Product Change Notice (PCN)

PCN Number: **PCN-0456169R-01**

Product(s) Affected: **PJ-031CH**

PREVIOUS CUI DEVICES DETAIL / IMAGE	NEW CUI DEVICES DETAIL / IMAGE

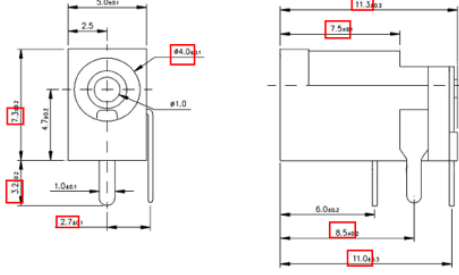
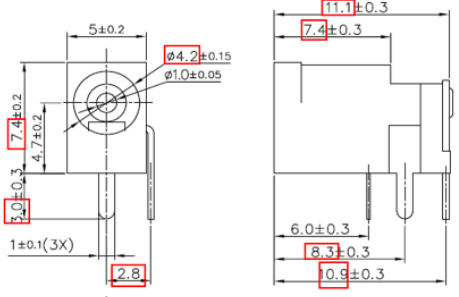
Description of Change: **Product re-engineered for improved manufacturability and production yield. See image below for product changes. Cosmetic differences may be visible and not affect the form fit and function of the product.**

<p>Recommended PCB Layout Top View</p>	 <p>Recommended PCB Layout Top View</p>

PREVIOUS CUI DEVICES DETAIL / IMAGE			NEW CUI DEVICES DETAIL / IMAGE		
DESCRIPTION	MATERIAL	PLATING/COLOR	DESCRIPTION	MATERIAL	PLATING/COLOR
center pin	brass	silver	center pin	brass	CuSn
terminal 1	brass t=0.50	silver	terminal 1	brass t=0.40	silver
terminal 2	MM alloy t=0.20	silver	terminal 2	stainless steel t=0.20	silver
terminal 3	brass t=0.50	silver	terminal 3	brass t=0.40	silver
housing	PA10T (UL94V-0)	black	housing	PA10T (UL94V-0)	black

<p>MATING PLUG Jack Insertion Depth: 7.0 mm</p>	 <p>MATING PLUG Jack Insertion Depth: 6.2 mm</p>
--	---
